## **ADDENDUM NO. 2**

Public Paving, Drainage, Water, Sanitary Sewer, Street  
Light & Traffic Signal  
Improvements

Intermodal Parkway BNSF to Old FM 156

**CITY PROJECT NO.:** 103332

DESIGNED: RZ	DATE: OCT 2022	FILE: SHEET
DRAWN: TCG		C704
CHECKED: KTW

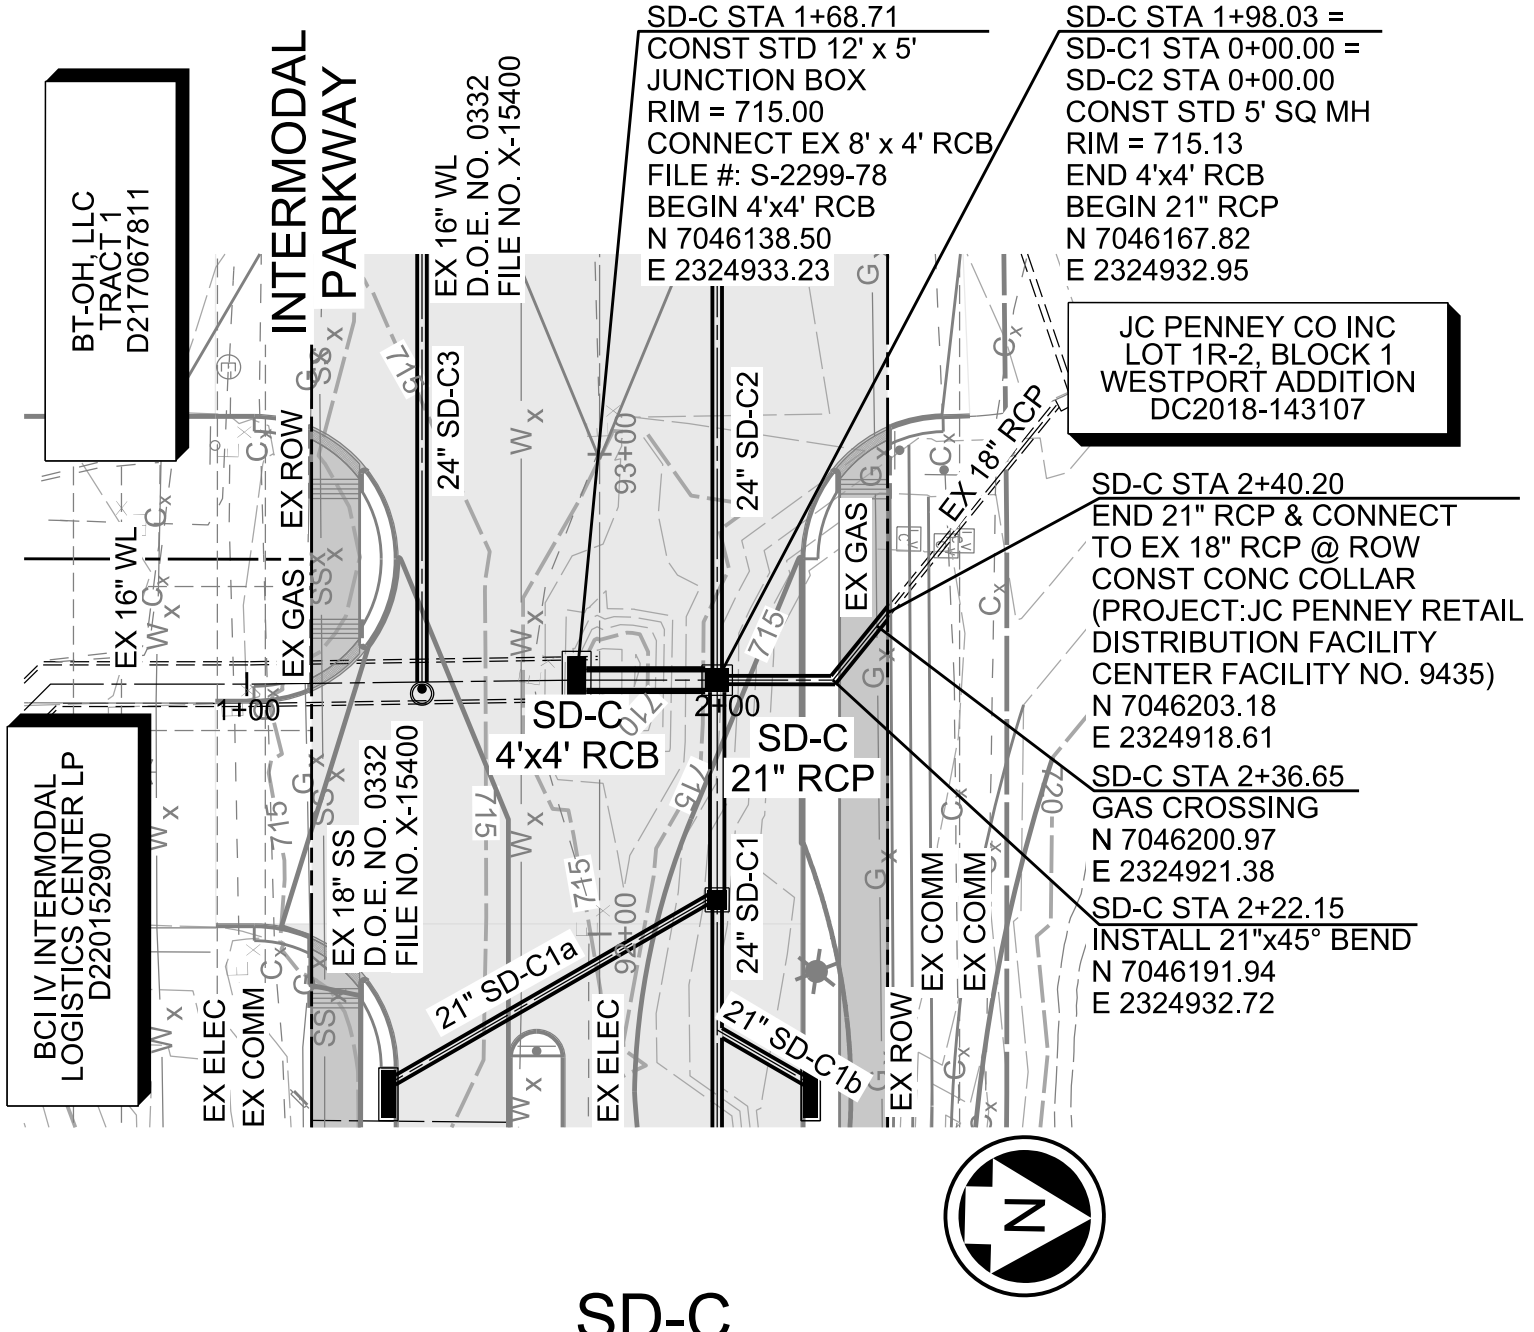
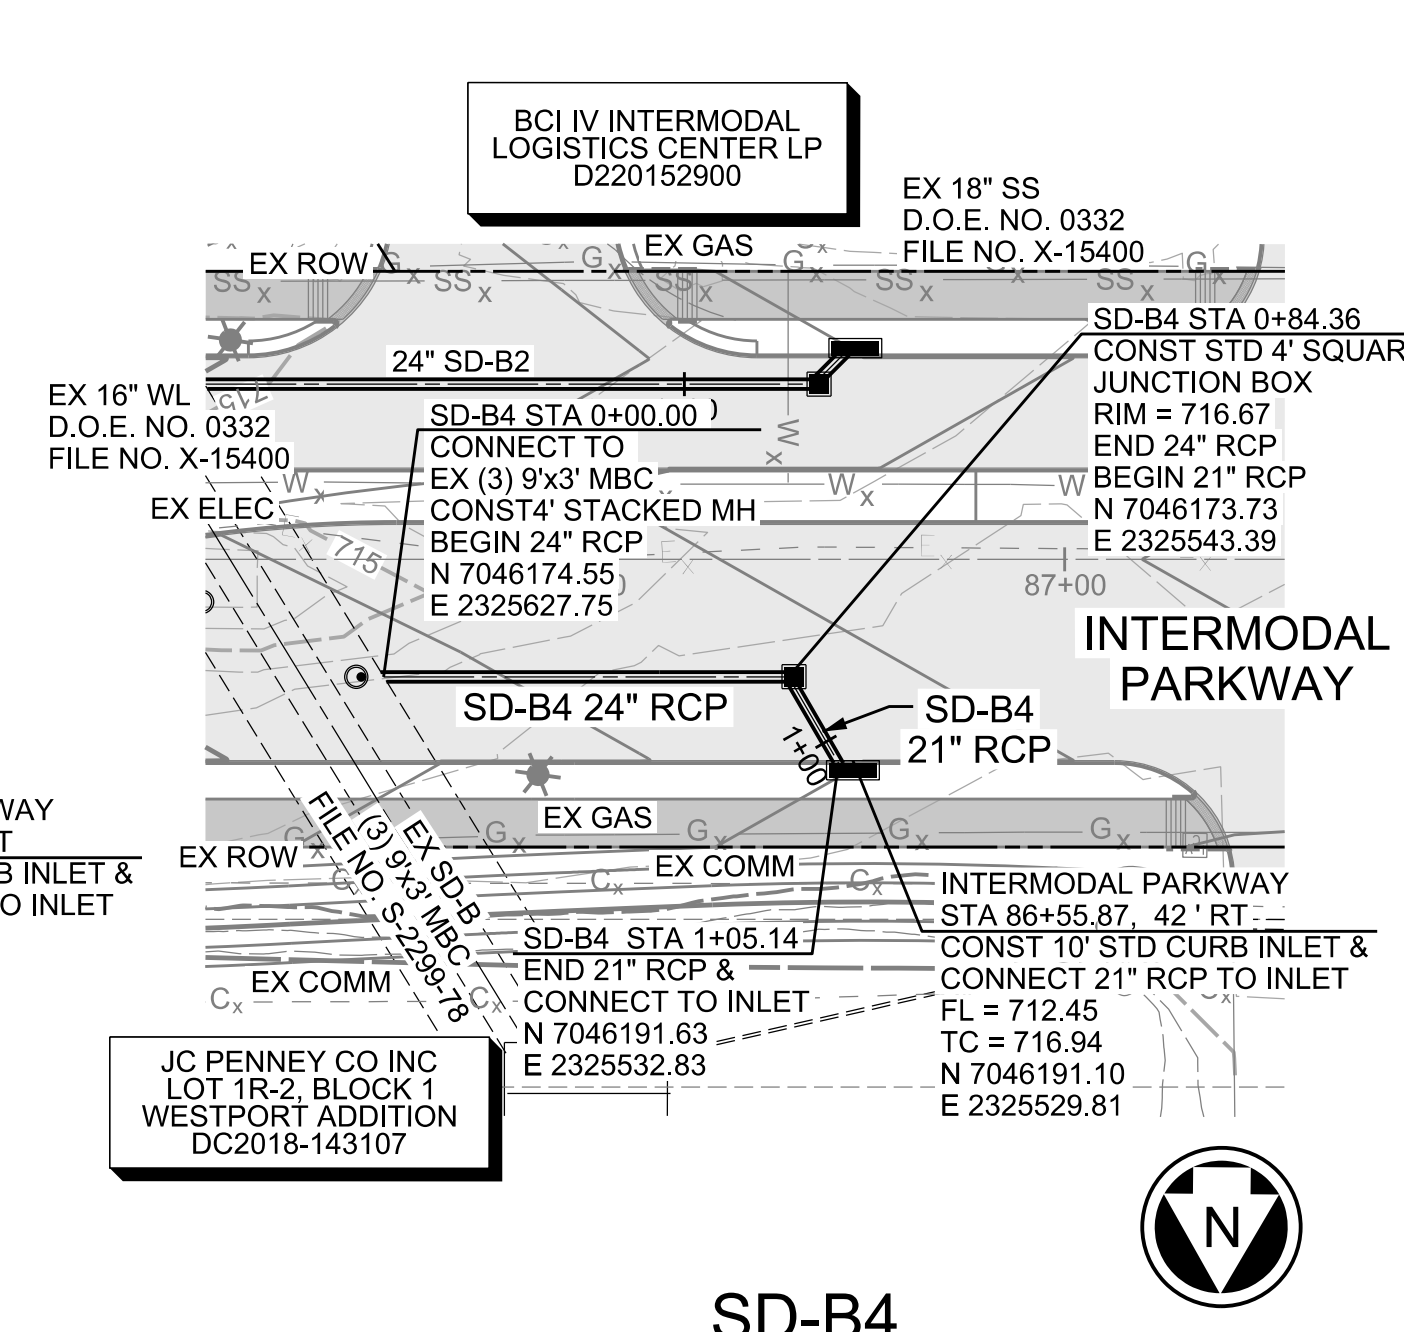
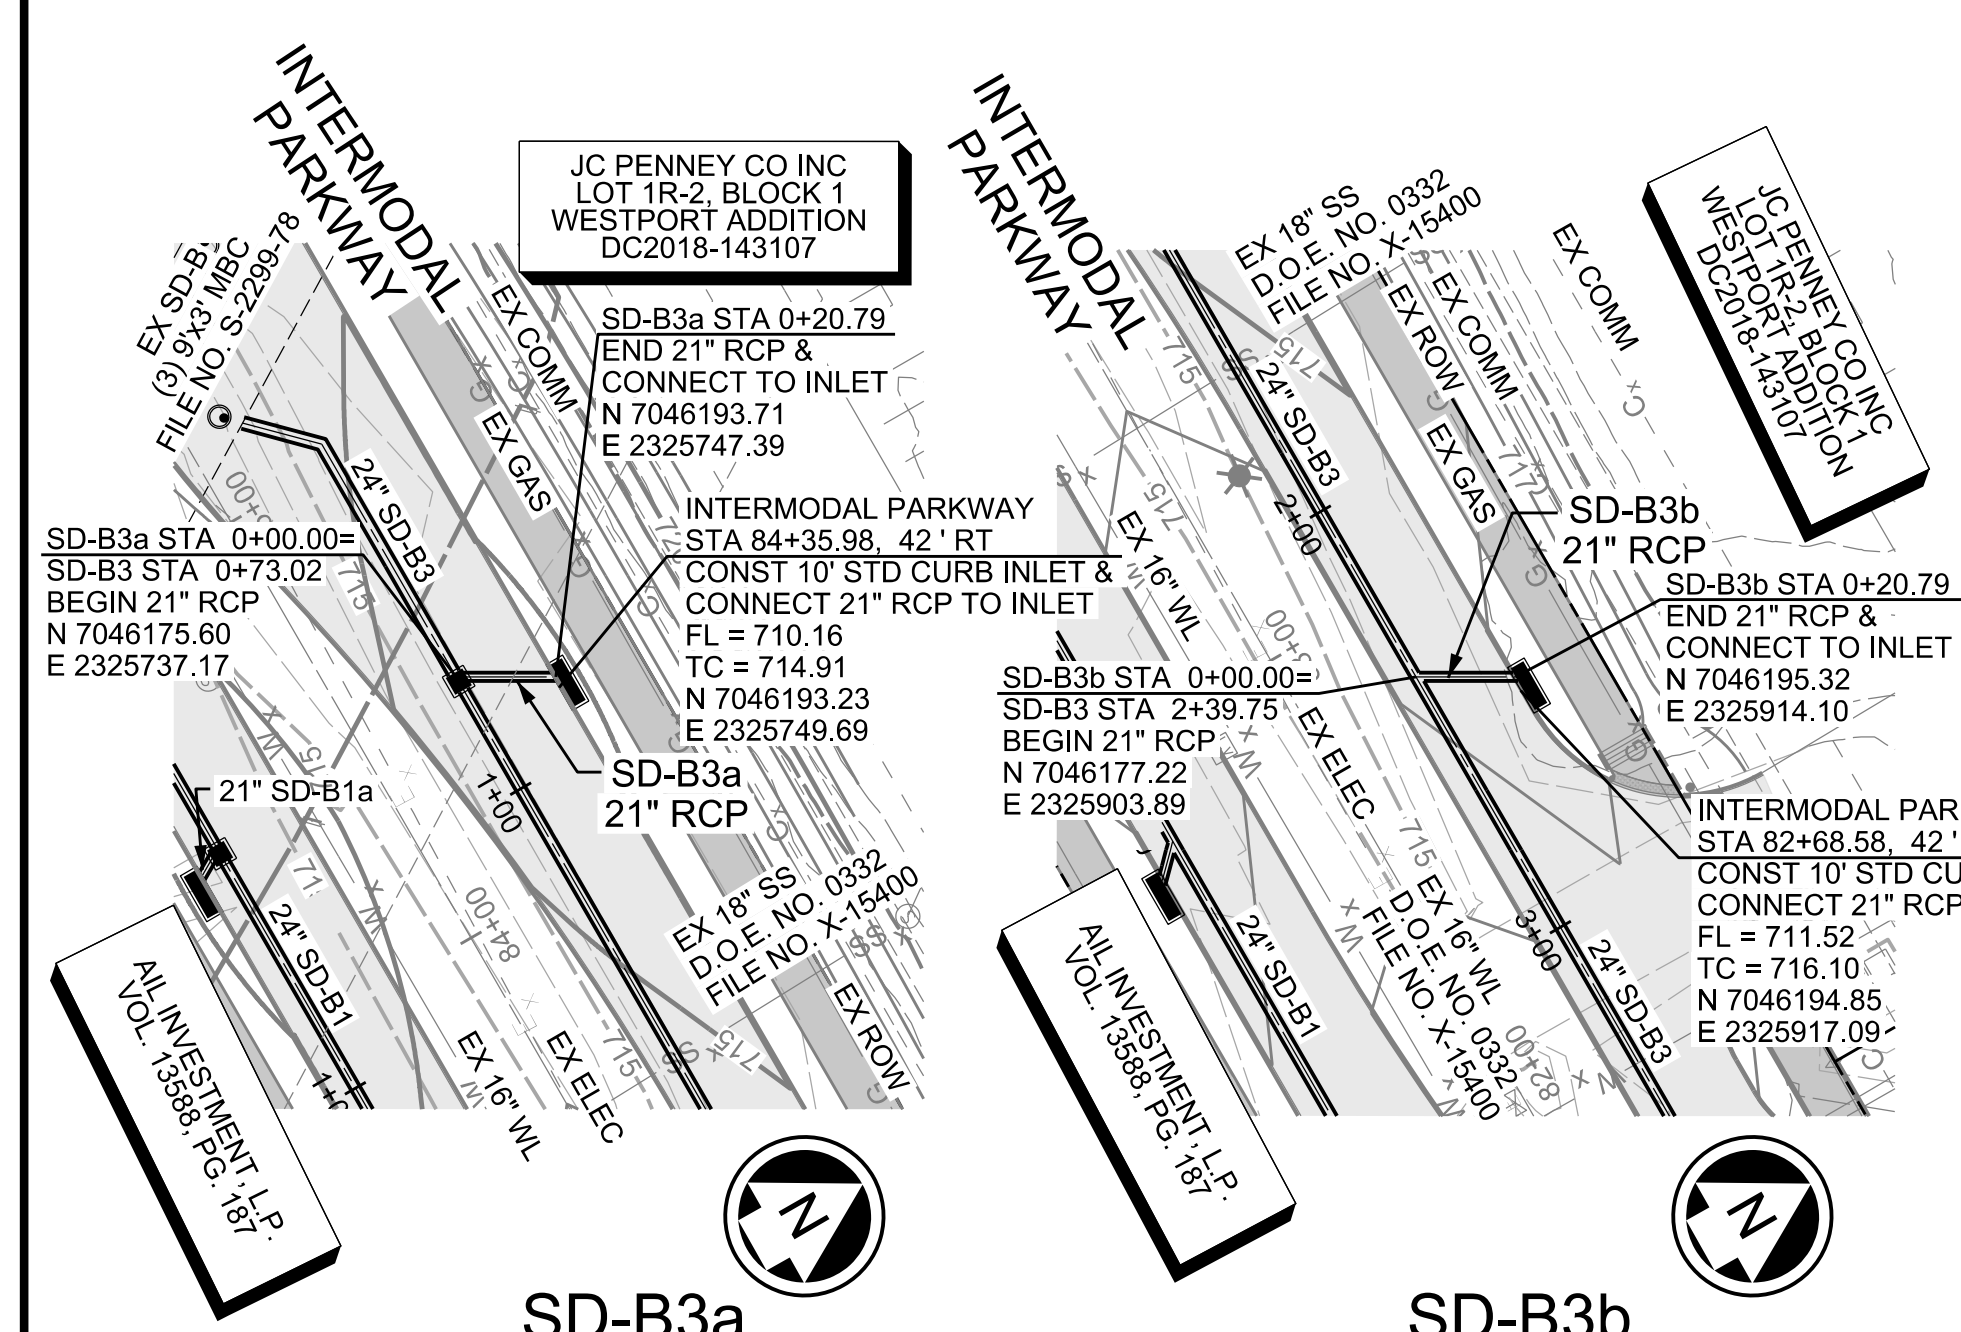
24. Document Modified: Sheet C704

Description of Change: Structural details have been updated to reflect a 9'4" x 12'10" drop inlet.

DESIGNED: RZ	DATE: OCT 2022	FILE	SHEET
DRAWN: TCG			C710
CHECKED: KTW

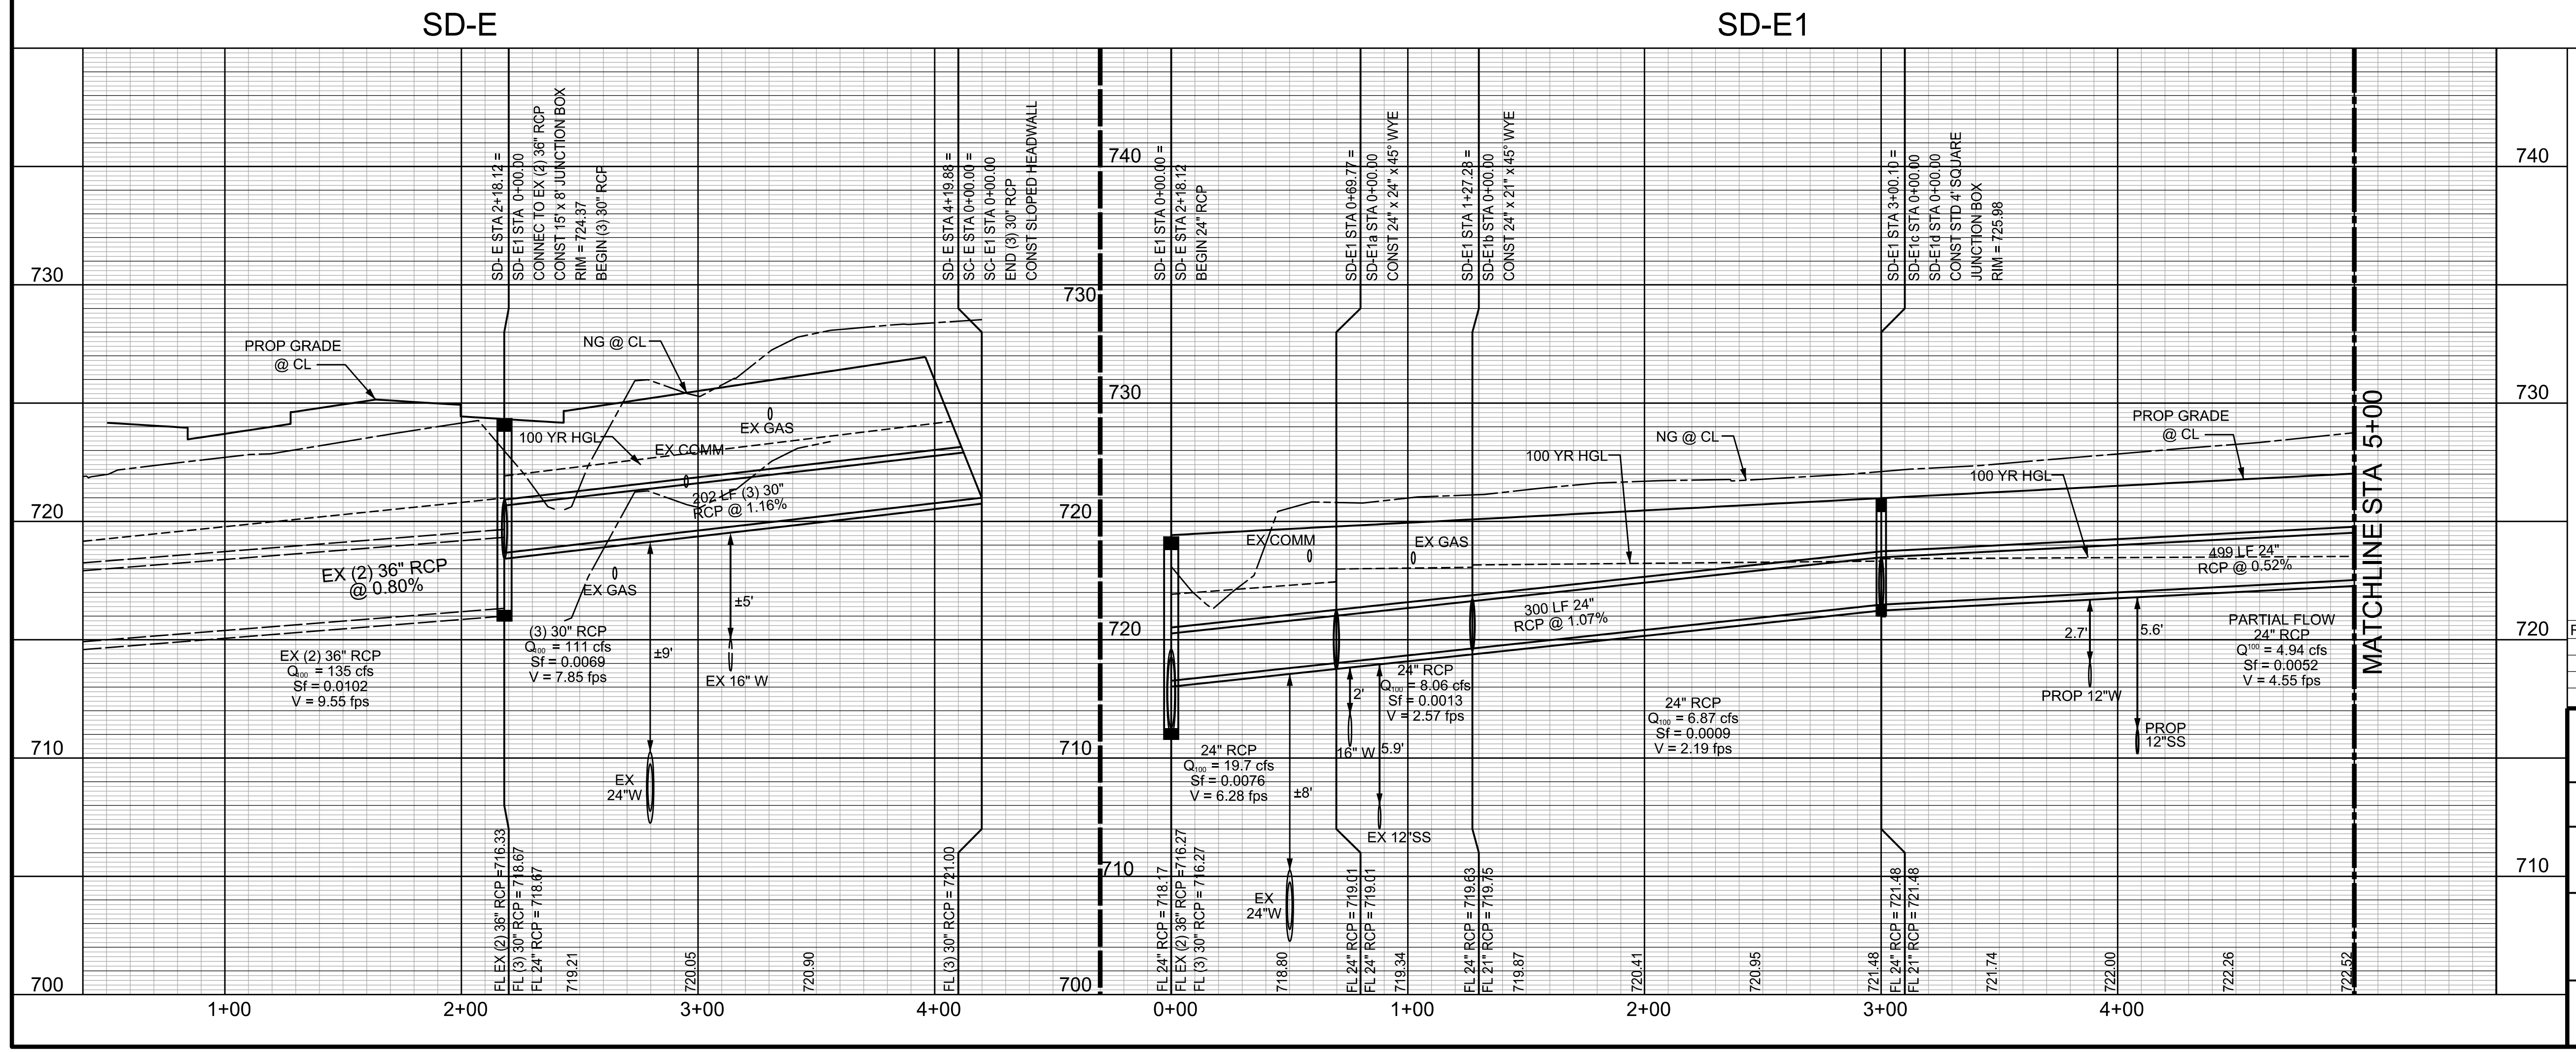
21. Document Modified: Sheet C710

Description of Change: Structural details have been updated to reflect a 12'x5' box culvert.
